Center for Auto Safety White Paper on Concerns With  
Chrysler Recall of the Jeep Grand Cherokee and Liberty  
Presented to NHTSA July 1, 2013

Chrysler has responded to the National Highway Traffic Safety Administration's request that it recall the Jeep Grand Cherokee and Liberty that have fuel tanks installed behind the rear axle for defects in their fuel systems with several specious arguments

Figure 1. A comparison with the subject Jeeps and other vehicles that Chrysler had purported to show had worse rear impact fire performance but which had no deaths due to fire in FARS in rear impacts where there was a fire in the listed vehicle.

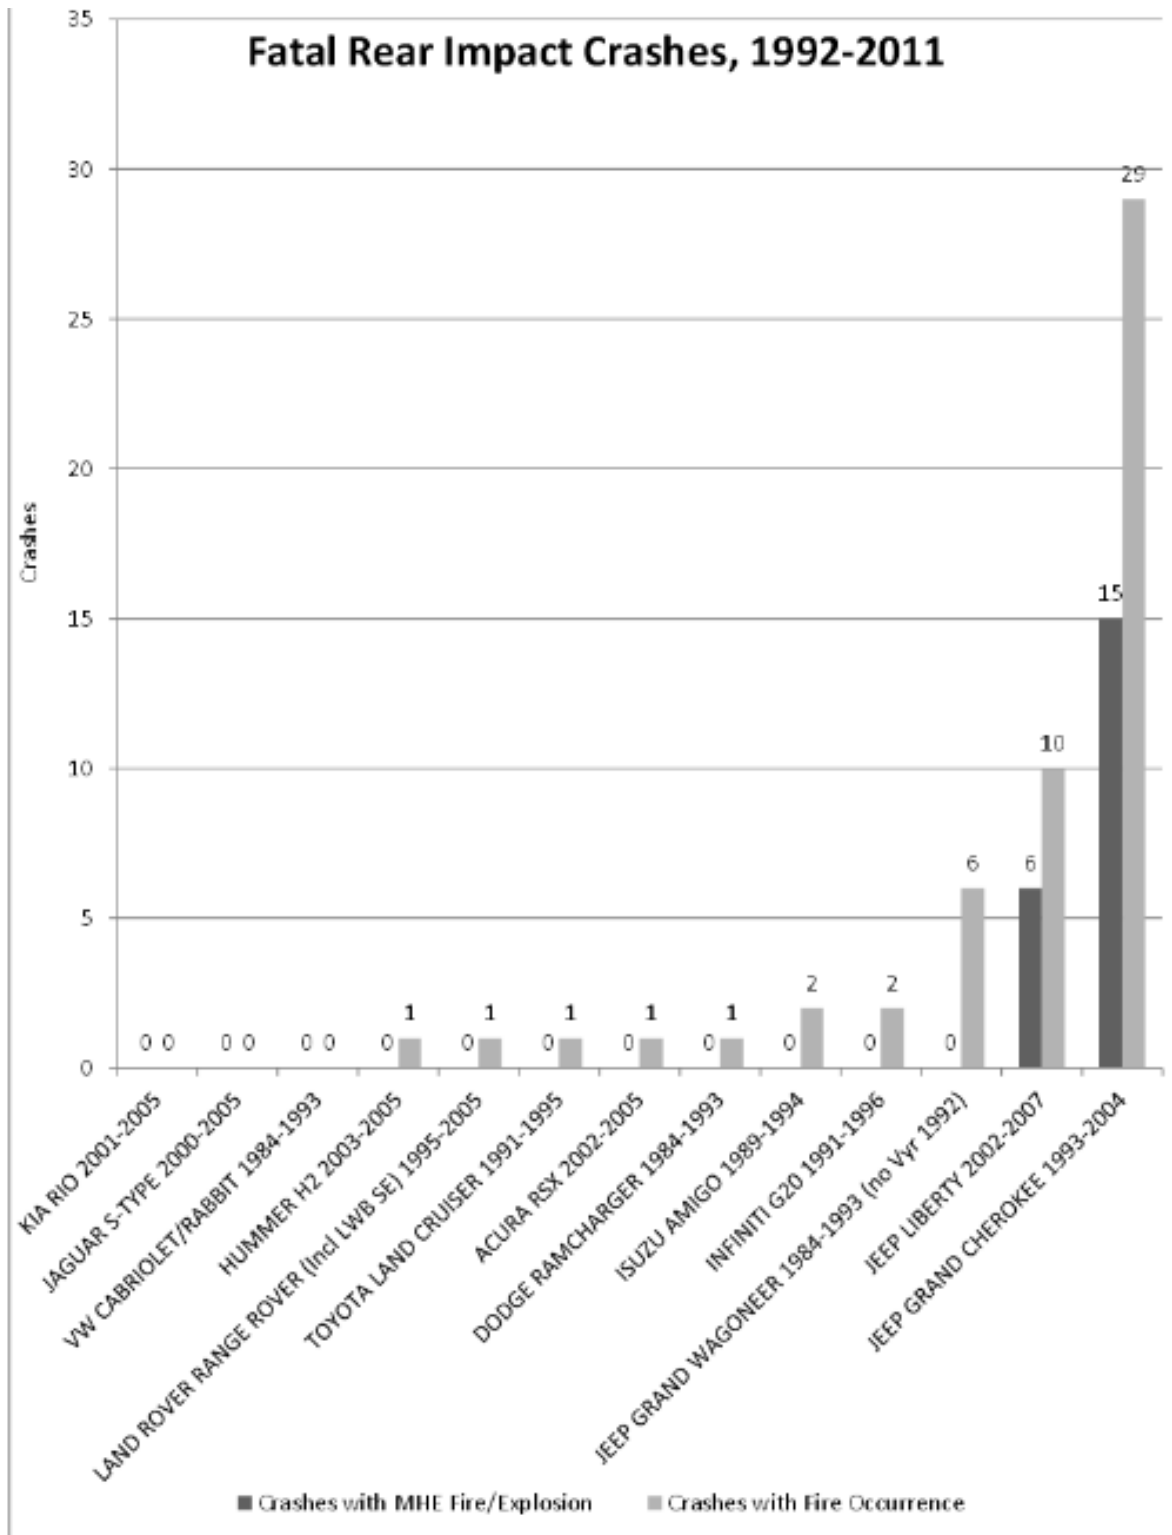
Chrysler included (Appendix D) an extensive discussion of confidence intervals in an attempt to show that one could not draw firm conclusions from the data where there were relatively small total numbers of relevant crashes. However, it is easy to see that the discrepancy between the performance of the subject Jeeps and other vehicles in Figure 1 is quite strongly indicative of a genuinely different crash experience between them and other vehicles in this chart. Similarly, the difference in the FARS data on Jeeps with fuel tanks mounted behind and ahead of the rear axle shows quite statistically different performance in the field. Chrysler does not discuss this appendix in the text of its June 18 letter because Appendix D shows that one cannot rely on the data behind its misleading comparison of various other makes and models to the Jeep Grand Cherokee and Liberty because the sample size and number of fatal fire crashes in such other models is so small.

Figure 2. A chart submitted by Chrysler as part of their early response to NHTSA's investigation. Note that while Chrysler combined sisters and clones in most cases, it did not combine the very small volume Honda Passport with its sister Isuzu Rodeo.

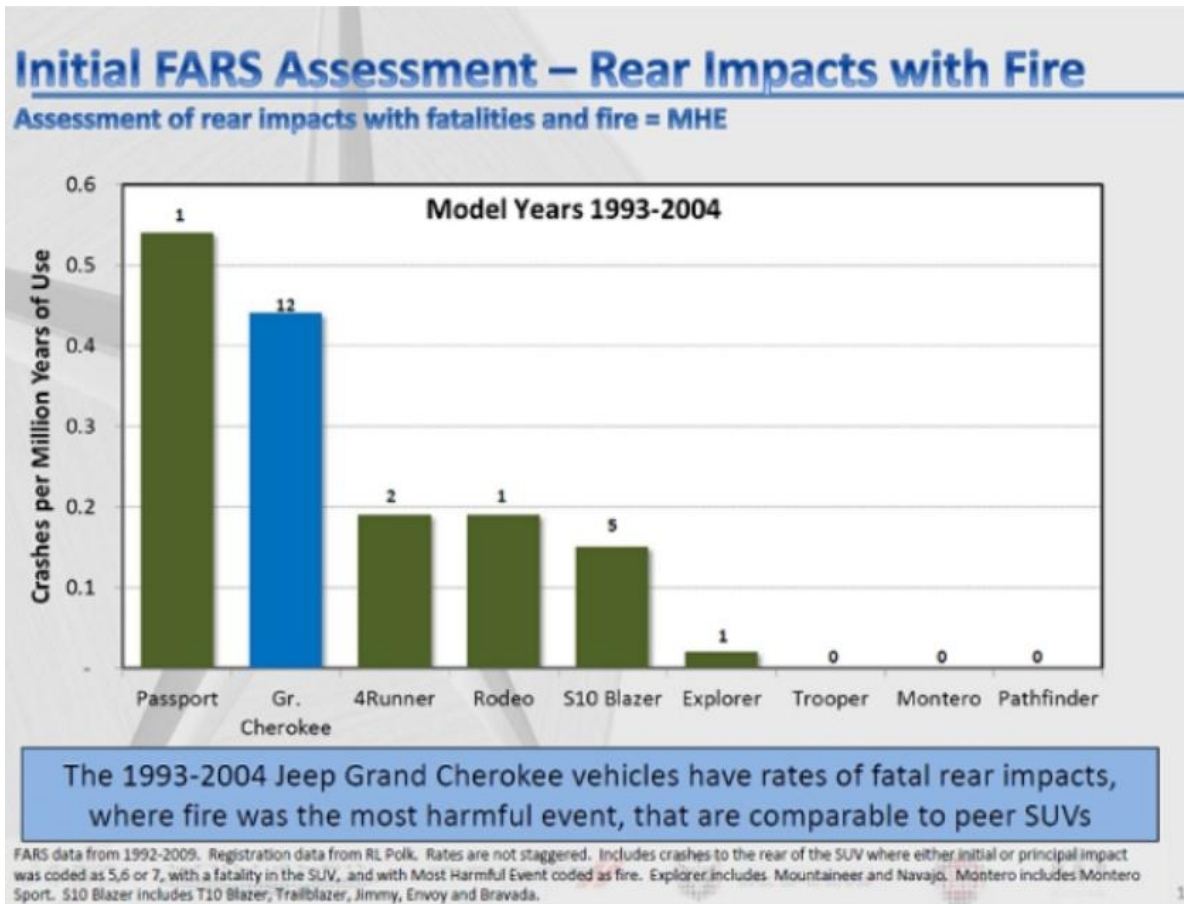
Looking at Chrysler's own chart which normalized these results (Figure 2) for the Grand Cherokee – with 12 cases where fire was the most harmful fatal event – had 4.4 per hundred thousand vehicle-years of use. The Honda Passport, which is a sister of the Isuzu Rodeo and should have been included with them, had only one crash on this chart, but when we looked at this case it was not even a rear impact but rather a frontal with a Chevrolet Tahoe.<sup>6</sup> (Also, because of the small population of these vehicles, there were a

very small number of vehicle years of use). None of the other vehicles in this chart had a rate greater than 2 per hundred thousand vehicle years of use.
